V2500-A5 SERIES SERIES PROPULSION SERVICE BULLETIN

This document transmits Revision 4 to Service Bulletin NV2500-71-0273

V2500-NAC-71-0273

NACELLE – ENGINE BUILD UNIT (EBU) – REPLACEMENT AND REROUTING OF SEVERAL EBU SYSTEMS
TO ACCOMMODATE THE REROUTING OF THE OIL SCAVENGE TUBES

Assembly of Clipping Points CP1464 and CP1465
Figure 6

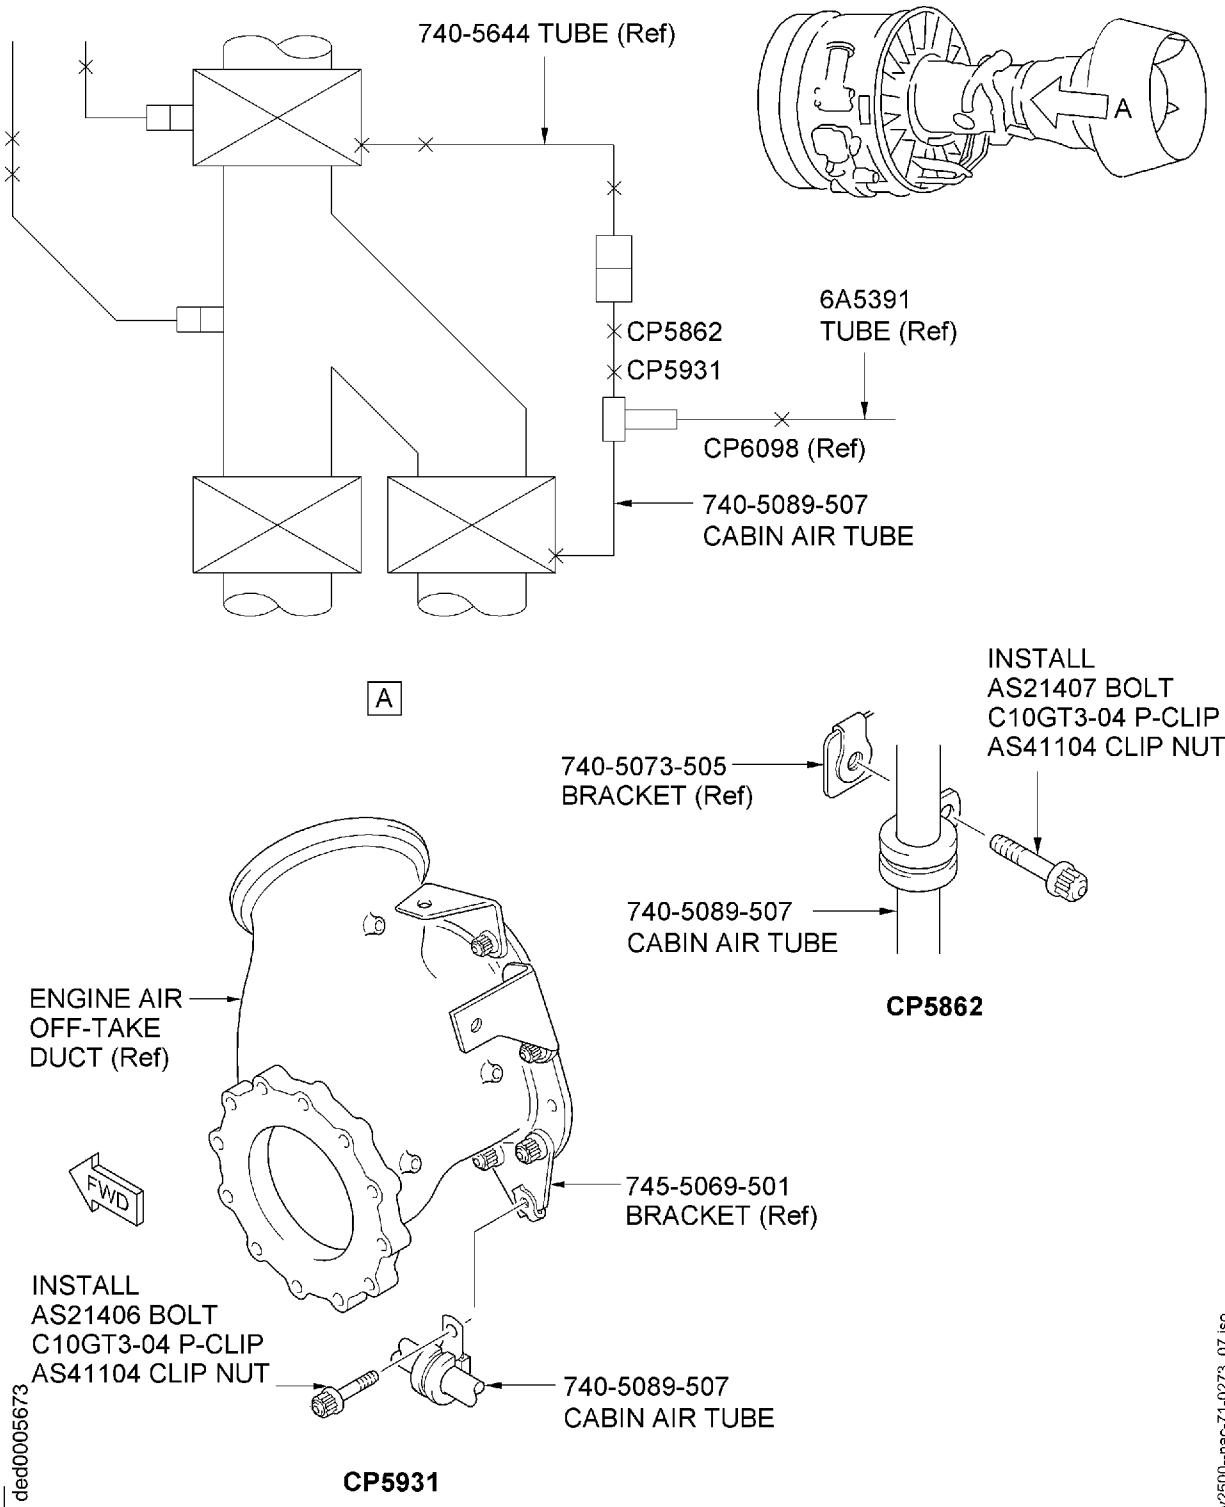
- (12) At Clipping Point CP1465, fit the 400WSS4 P-Clip to the 740-5261 Drain Tube and attach to the 6A6237 Raceway. Refer to Figure 6.

- (11) At Clipping Point CP1465, fit the 400WSS4 P-Clip to the 740-5261 Drain Tube and attach to the 6A6237 Raceway. Refer to Figure 6.

Installation of the Cabin Air Tube
Figure 7

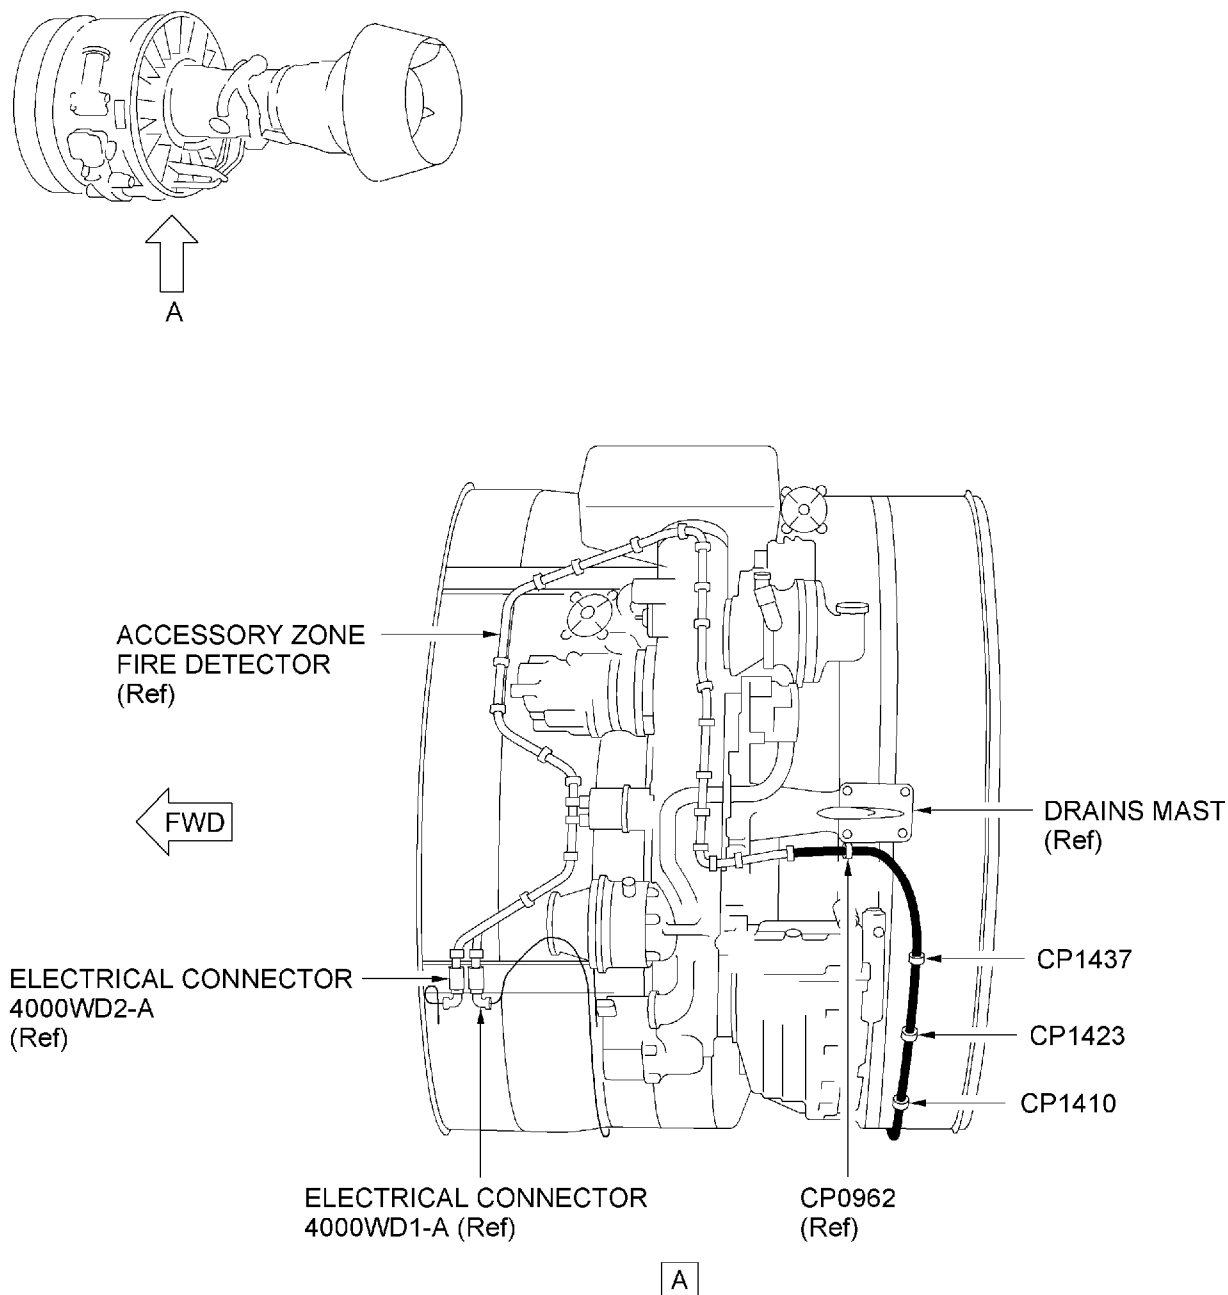
| (a) Apply CoMat 10-031 Anti-Galling Compound to the threads of the new 740-5089-507 Cabin Air Tube. | Remove the applicable covers/caps/plugs from the Engine components. |
| (b) Connect the 740-5089-507 Cabin Air Tube to the 740-5644 Tube. | Refer to Figure 7. |

Installation of the 7702-04 (Meggitt) or 473873-7 (Kidde) Fire Detector
Figure 8, Sheet 1 of 2

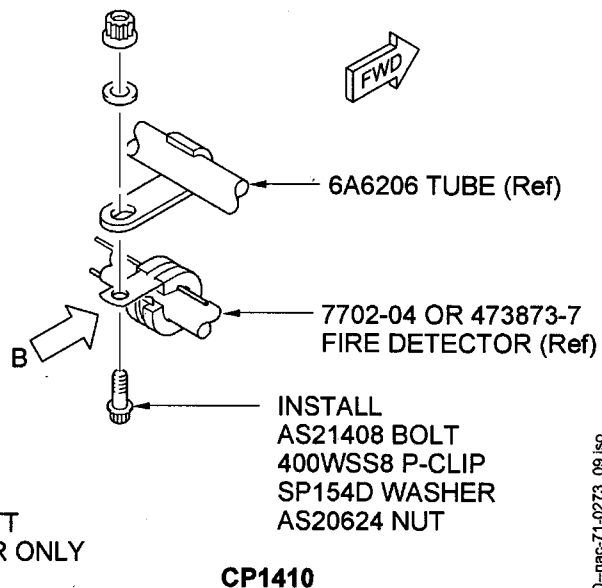
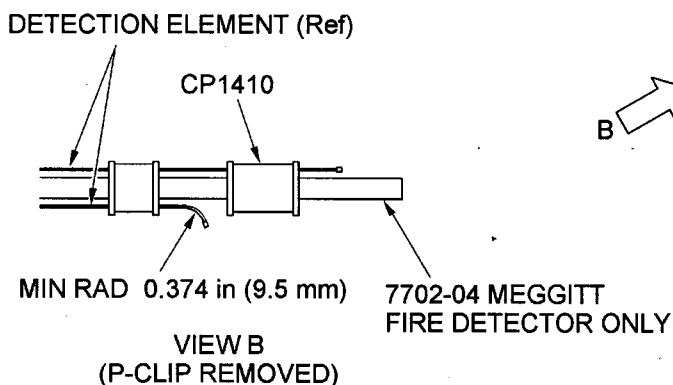
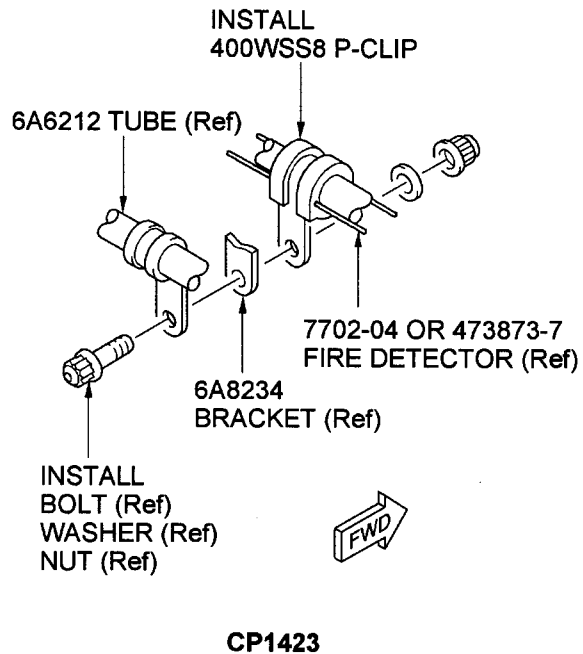
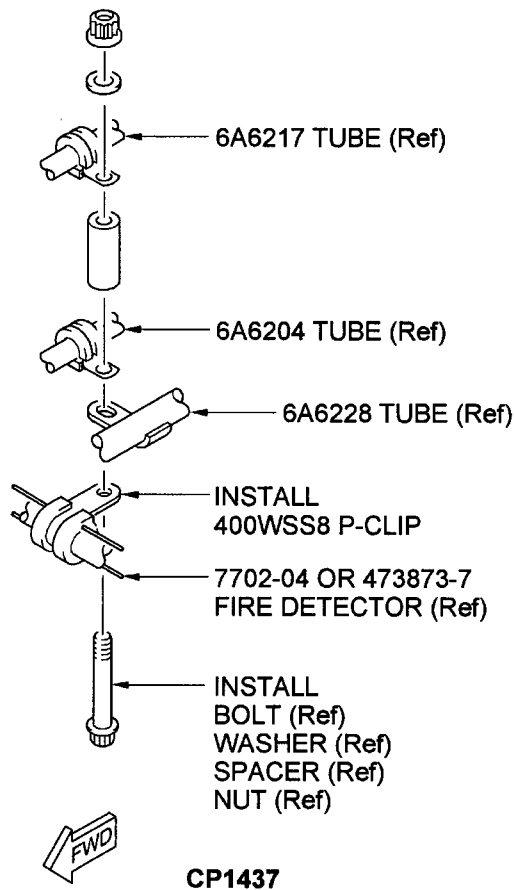
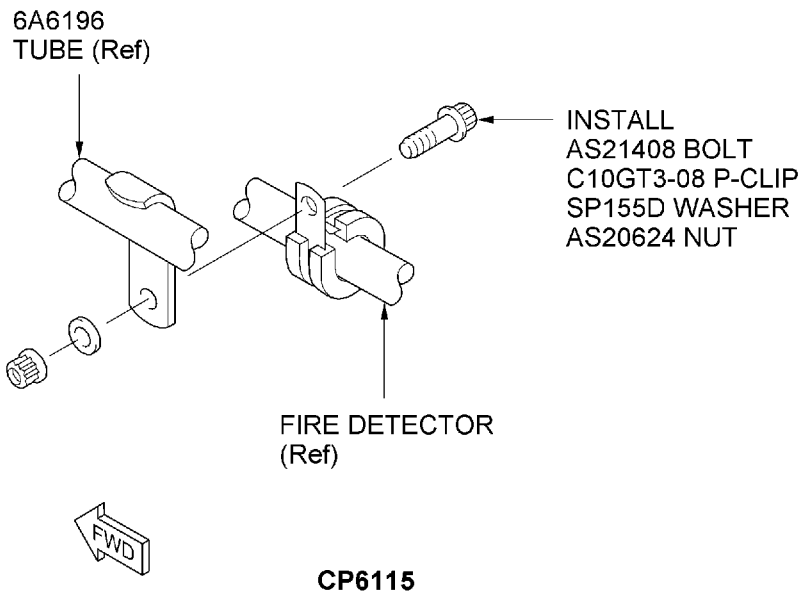
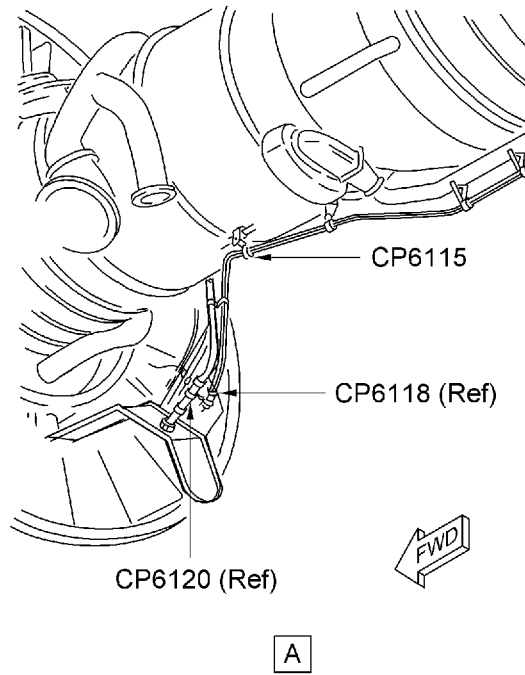
| (b) Clipping Point CP1437 – Attach the Fire Detector to the 6A6228 Tube, the 6A6204 Tube and the 6A6217 Tube with the 400WSS8 P-Clip. | Refer to Figure 8. |

Refer to Figure 8 view B.

Refer to Figure 8.

Refer to Figure 8.

Refer to Figure 8 view B.

Refer to Figure 8.

Installation of Clipping Point CP6115 on the Core Fire Detector
Figure 9

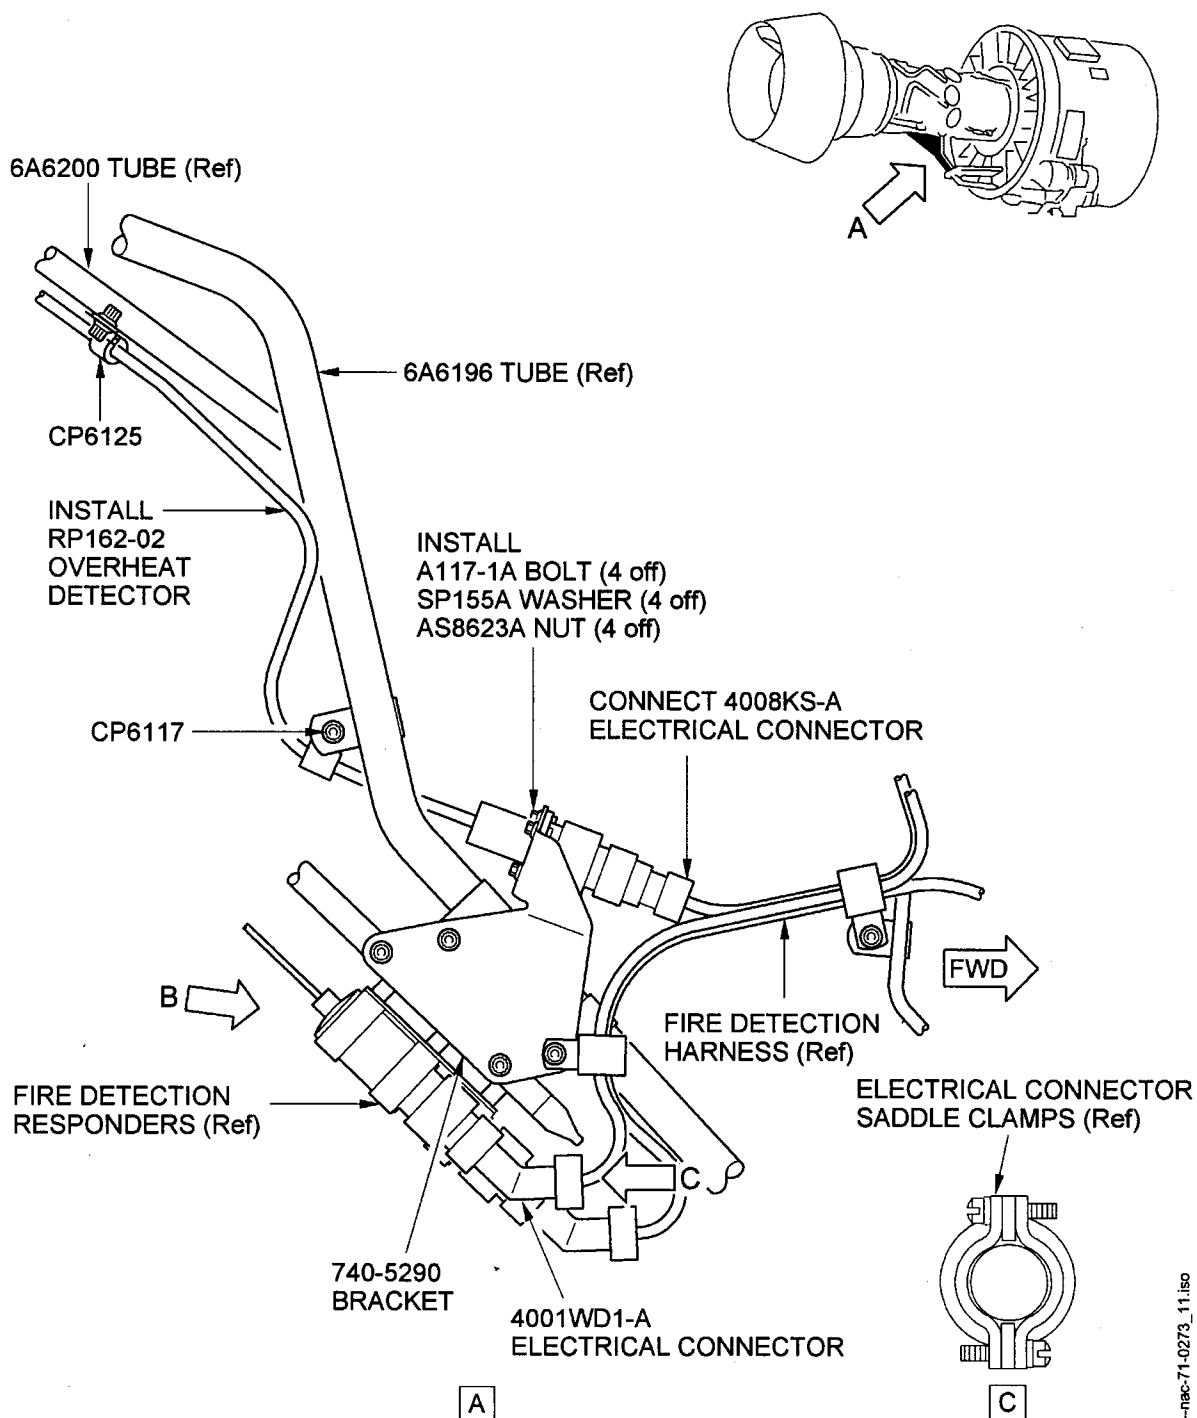
(16) Modification of Core Fire Detector routing.

Refer to Figure 9.

(14) Modification of Core Fire Detector routing.

Refer to Figure 9.

Installation of the Overheat Detector and Bracket
Figure 10, Sheet 1 of 2

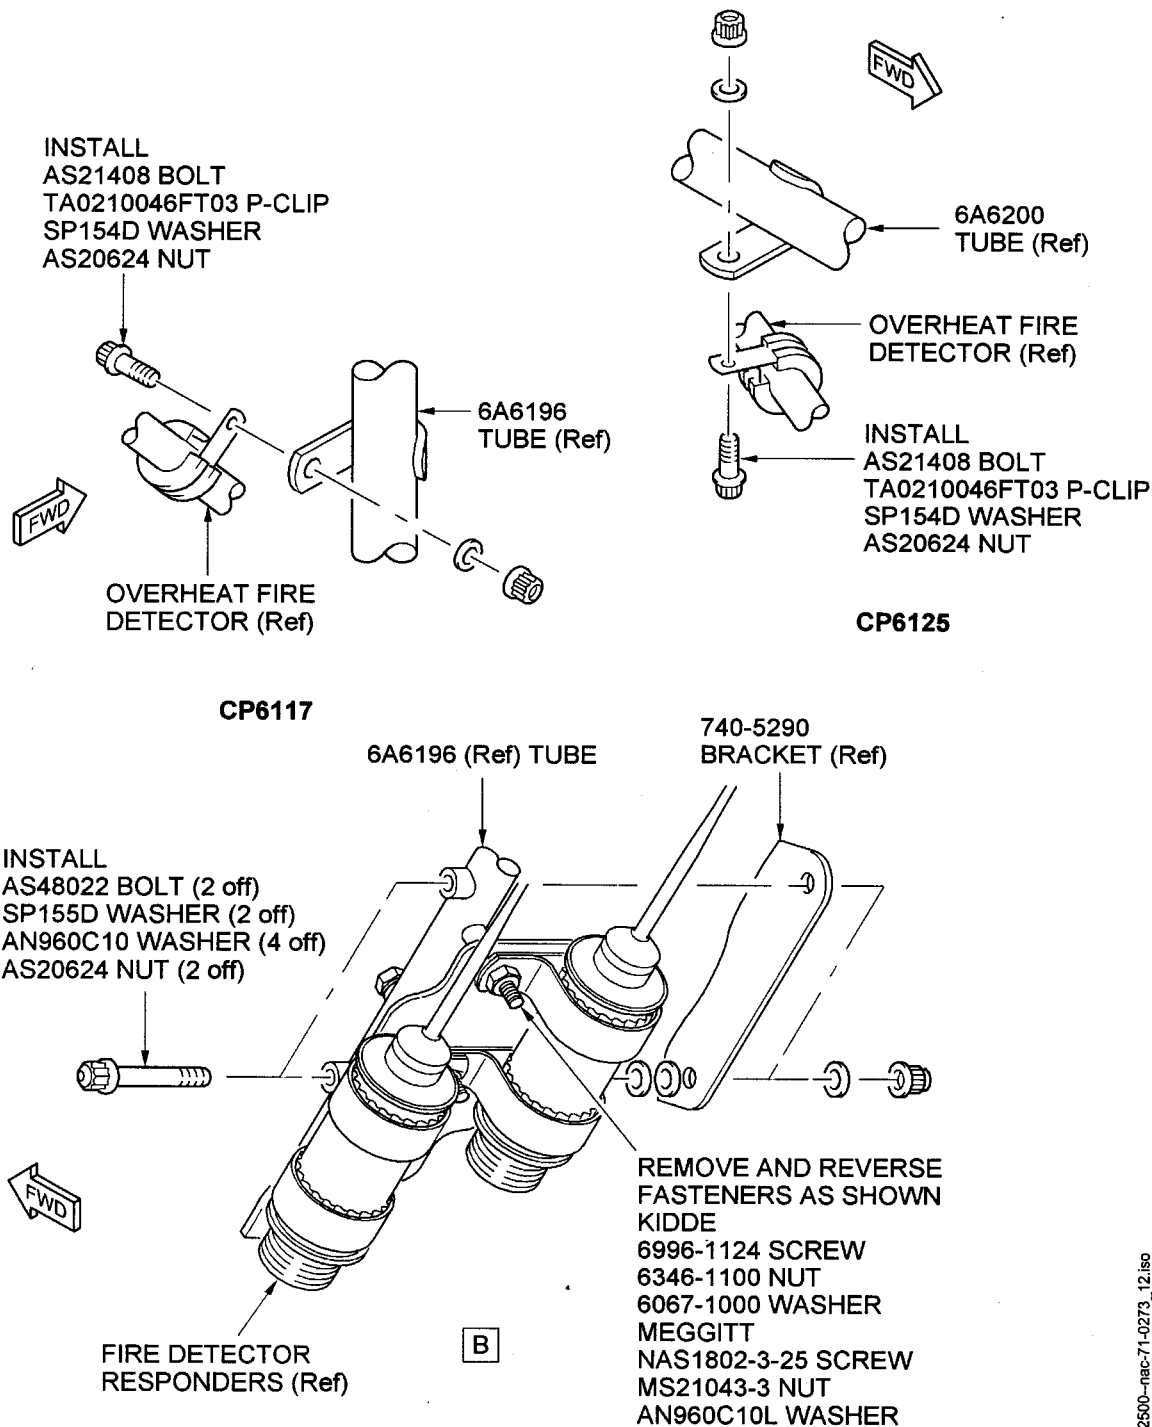
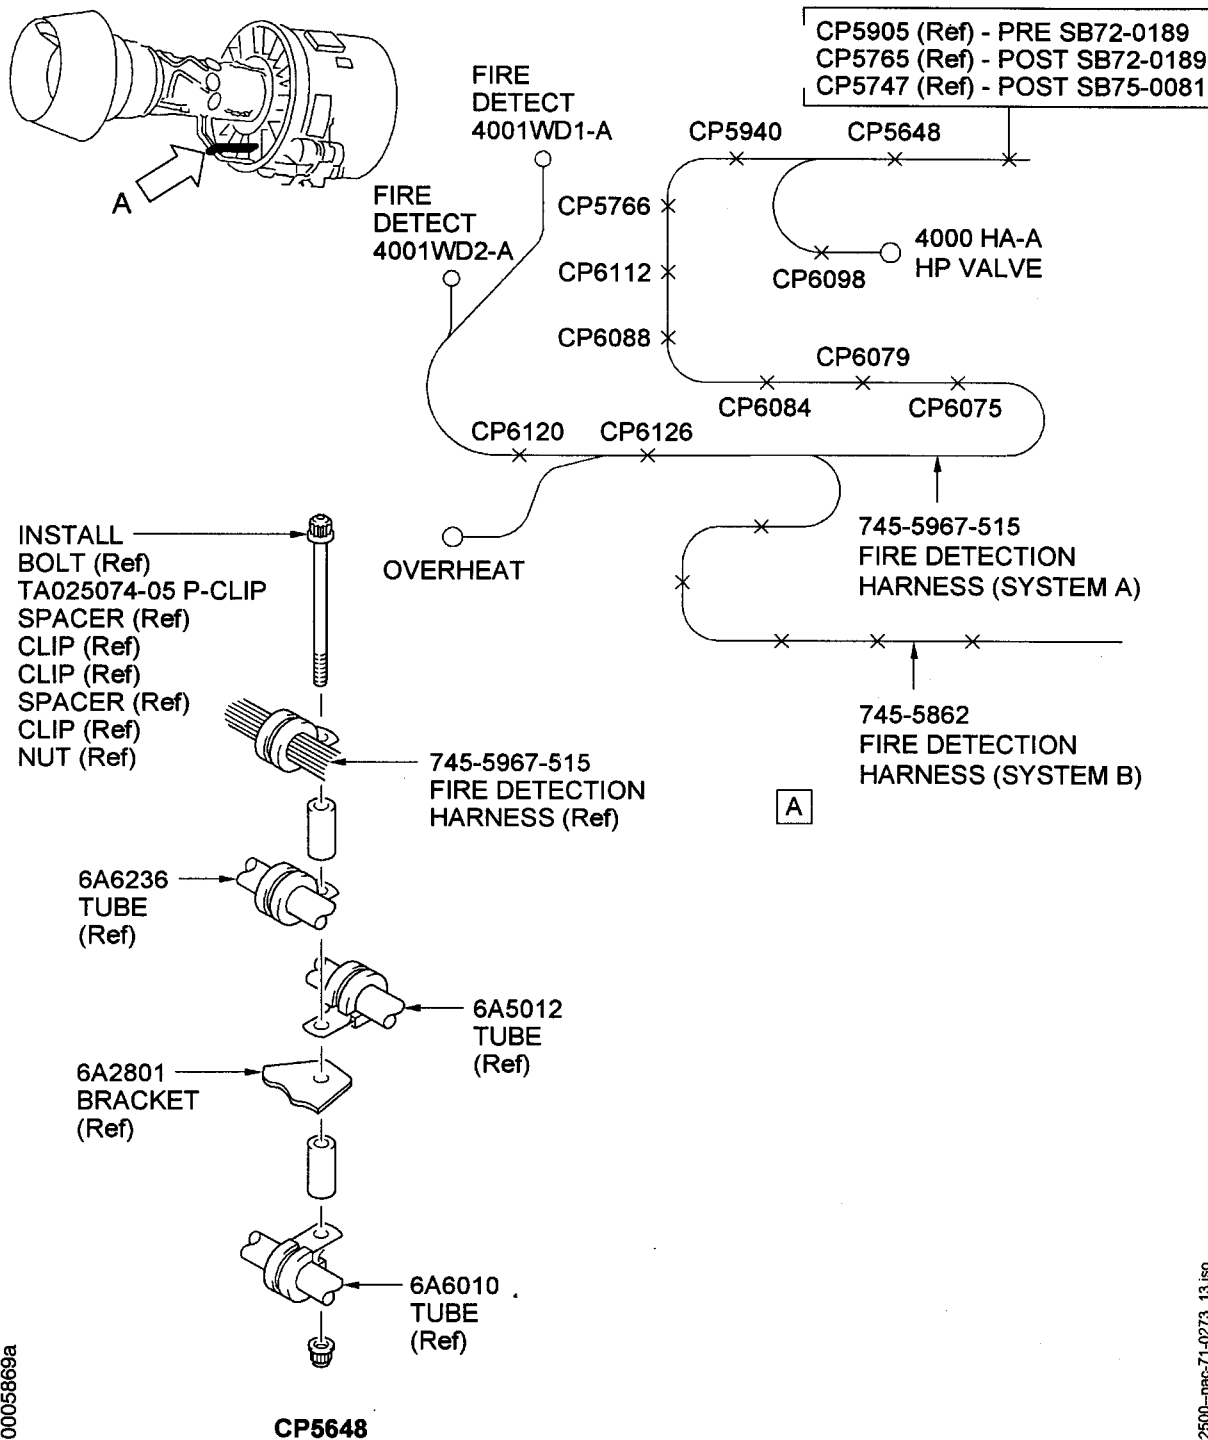
Refer to Figure 10.
Lubricate the Bolts with Engine Oil CoMat 10-039 or CoMat 10-040.

(a) For the Meggitt Fire Detector Only: To prevent a foul condition with adjacent hardware remove the three NAS1802-3-25 Screws, MS21043-3 Nuts and AN960C10L Washers and install in the reverse orientation. Torque the Nuts to 35 lbfin (3,95 Nm).

Refer to Figure 10.
Make a mark of the Service Bulletin No. 'V2500-NAC-71-0273' on the Fire Detector Plate.

(c) Install the Fire Detector Responders to the 740-5290 Bracket with the two AS48022 Bolts, the four AN960C10 Washers, the two SP155D Washers and the two AS20624 Nuts. Refer to Figure 10.

- If necessary, clock the saddle clamps of the 4001WD1-A Electrical Connector to approximately 12 O'Clock to achieve maximum clearance with adjacent hardware. Refer to Figure 10 sheet 1.

Refer to Figure 10.
Lubricate the Bolts with Engine Oil CoMat 10-039 or CoMat 10-040.

(a) For the Meggitt Fire Detector only: To prevent a foul condition with adjacent hardware remove the three NAS1802-3-25 Screws, MS21043-3 Nuts and AN960C10L Washers and install in the reverse orientation. Torque the nuts to 35 lbfin (3,95 Nm).

Refer to Figure 10
Make a mark of the Service Bulletin No. 'V2500-NAC-71-0273' on the Fire Detector Plate.

Refer to Figure 10.

If necessary, clock the saddle clamps of the 4001WD1-A Electrical Connector to approximately 12 O'Clock to achieve maximum clearance with adjacent hardware. Refer to Figure 10 sheet 1.</p> |
